#123090341 IN

Site Safety Plan for:
1568 AIR BROADWAY,
NY, NEW YORK

PROJECT:
Alt-2 In Conjunction with Alt-1 At 45 Str
1568 Air Broadway New York, NY 10036,
544' HT Block 999, Lot 9062, CB 105
Alt1 Job # 121191236,
Alt2 Job # 123090341
BIN: 1085494

coordinate with Demo disapproved comments

PHASE 1 STRUCTURAL DEMO -
SECTION 1 43-17

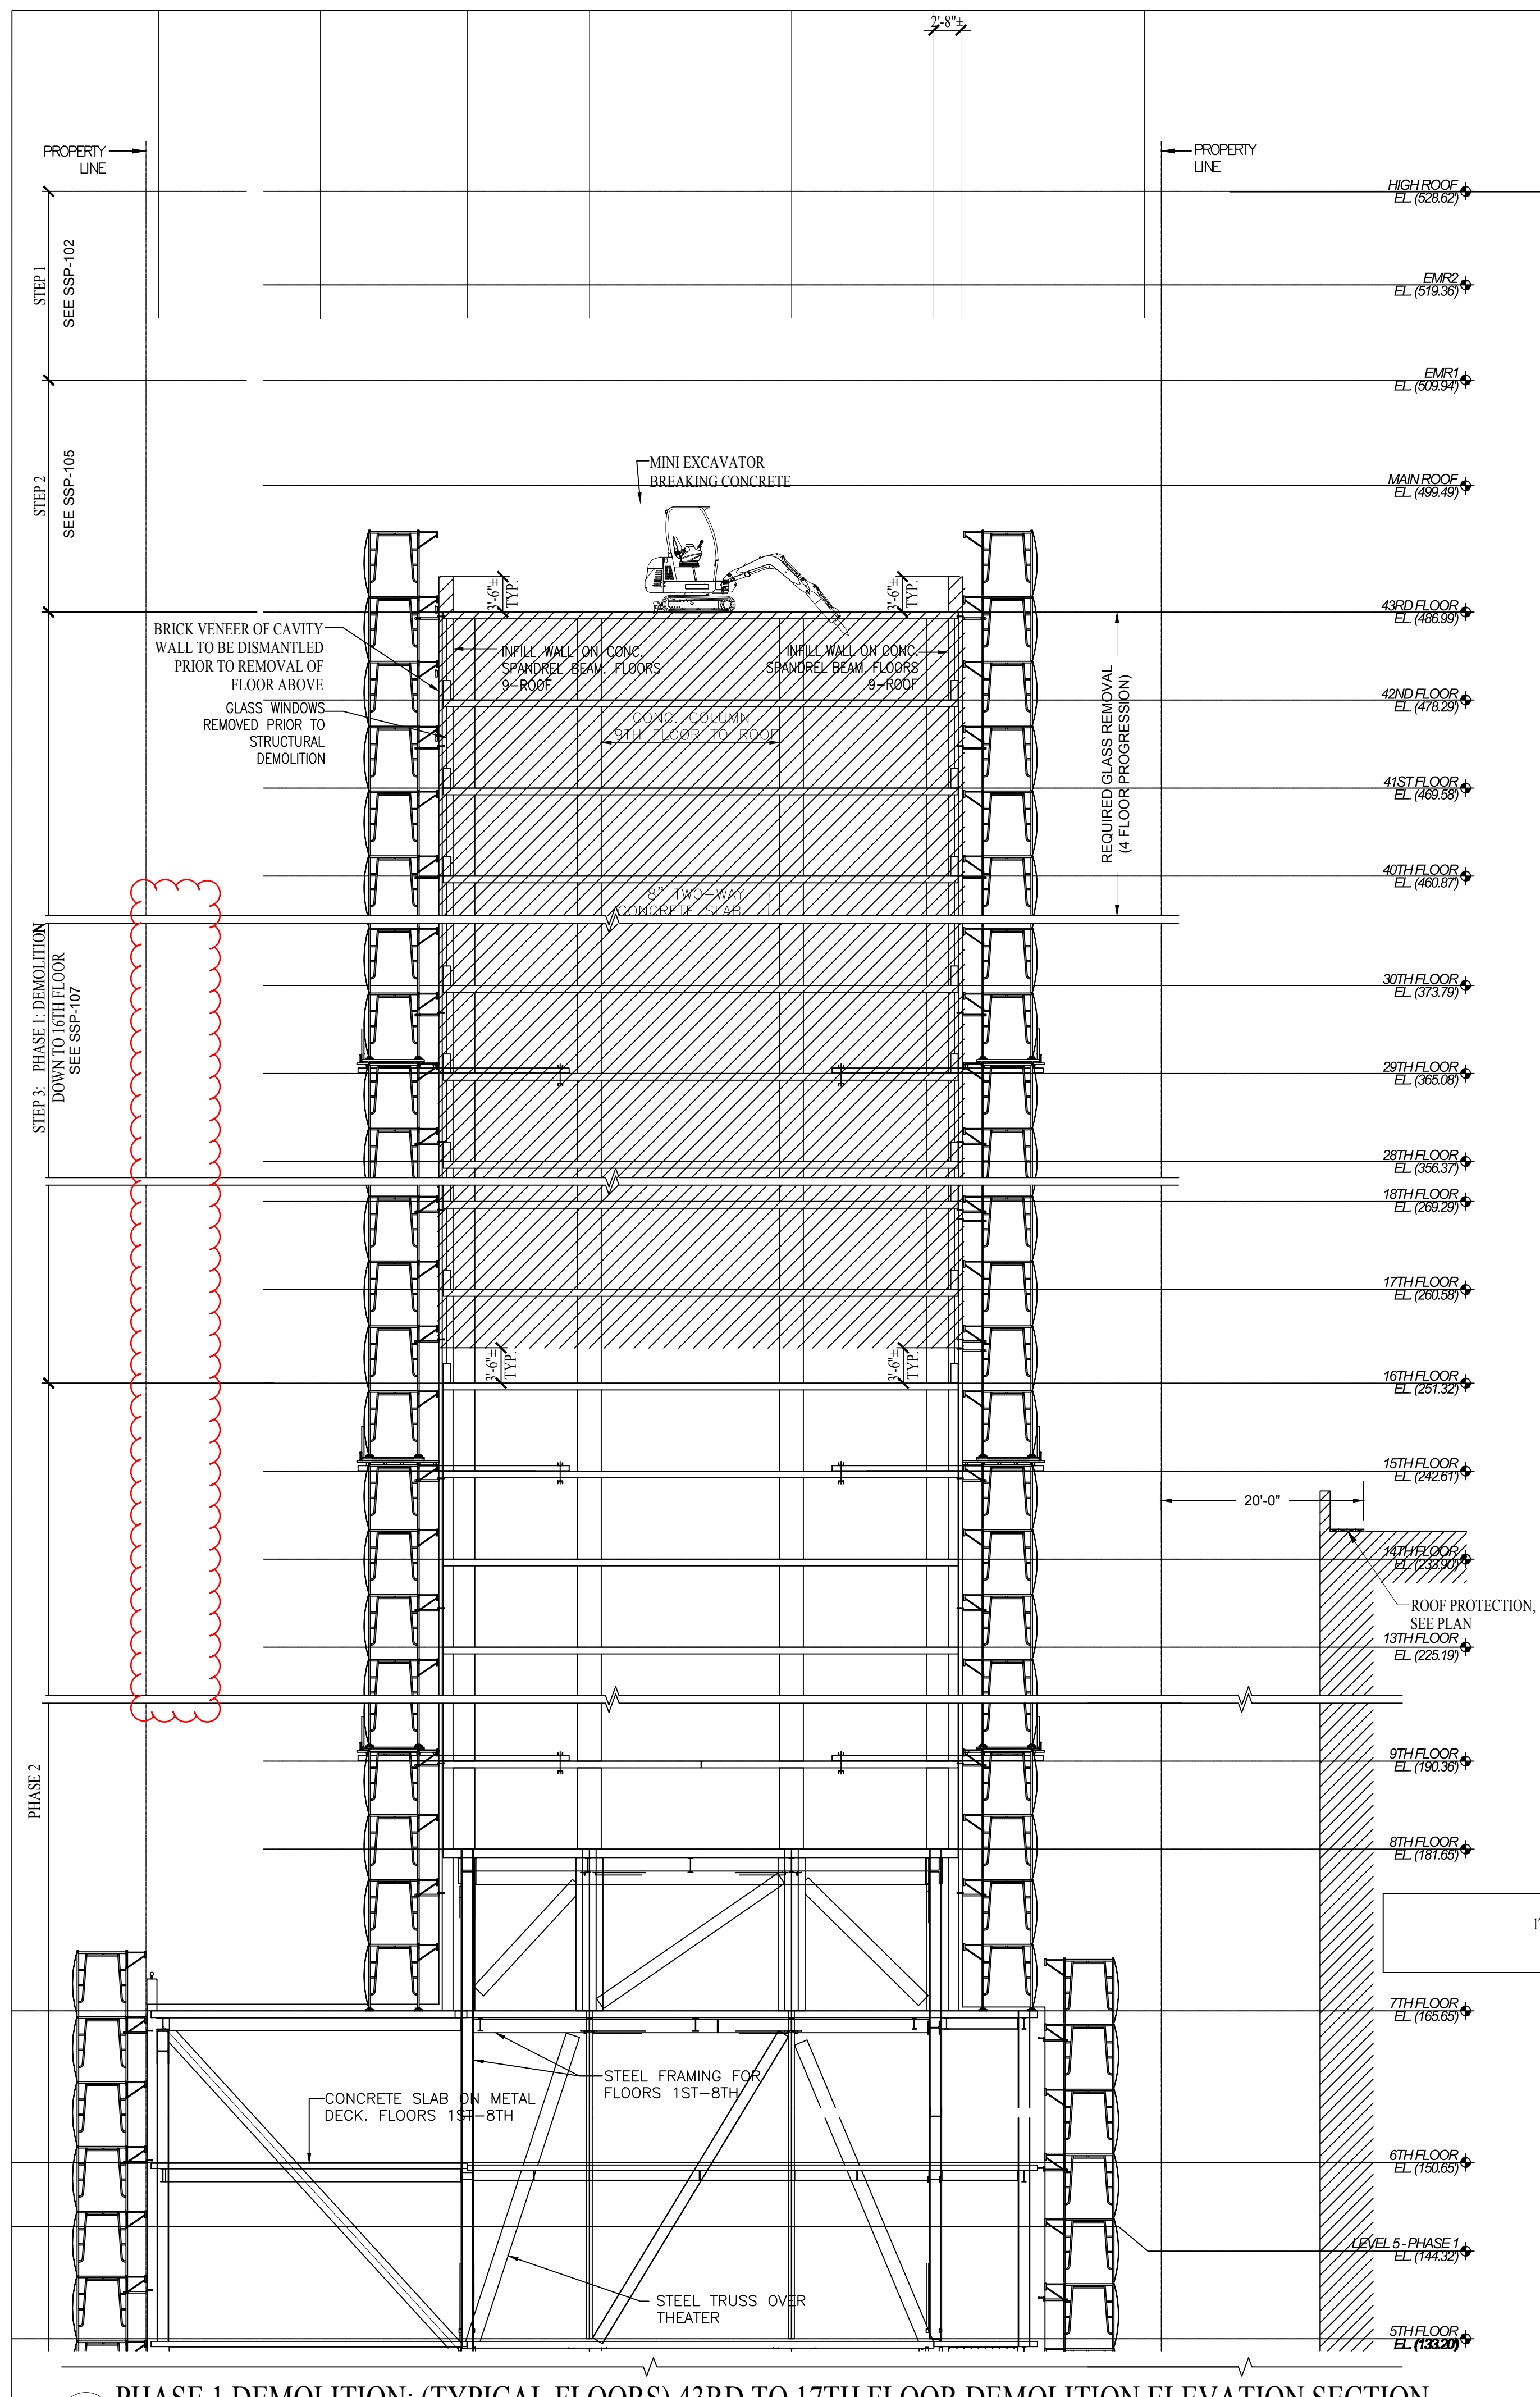
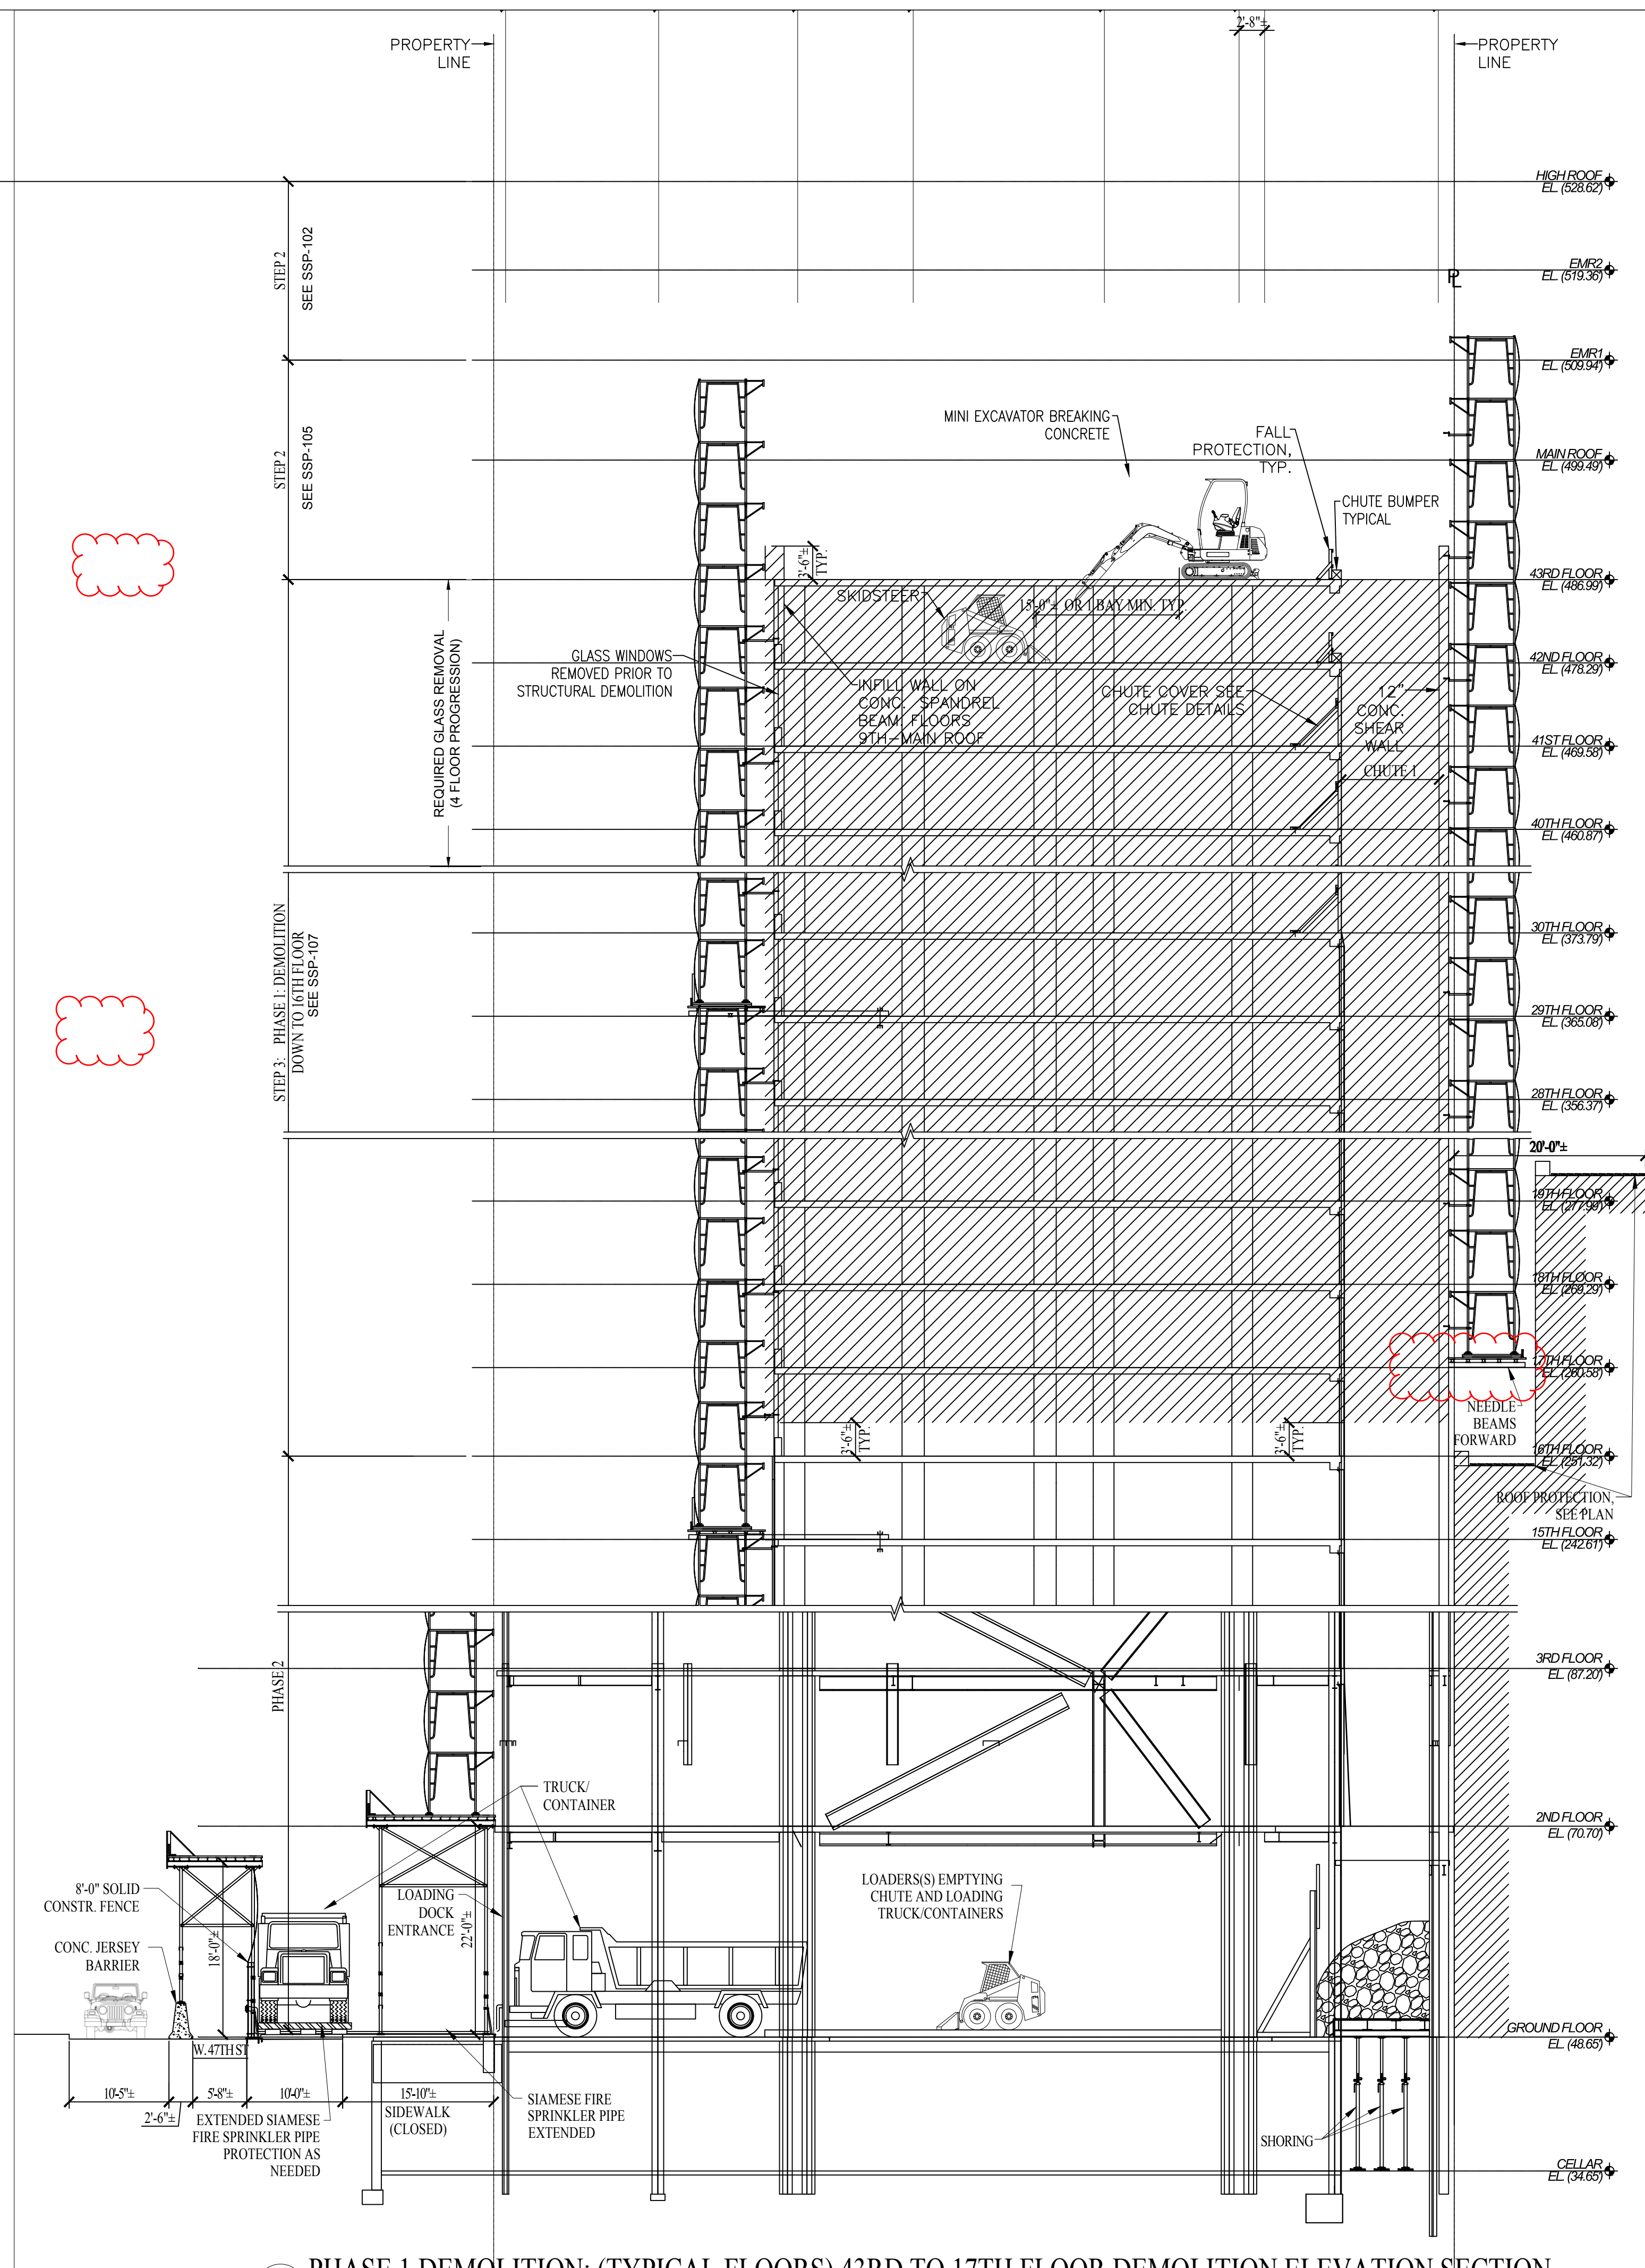
Provide protection above workers removing glass
panels when structural demo is being done at
perimeter above
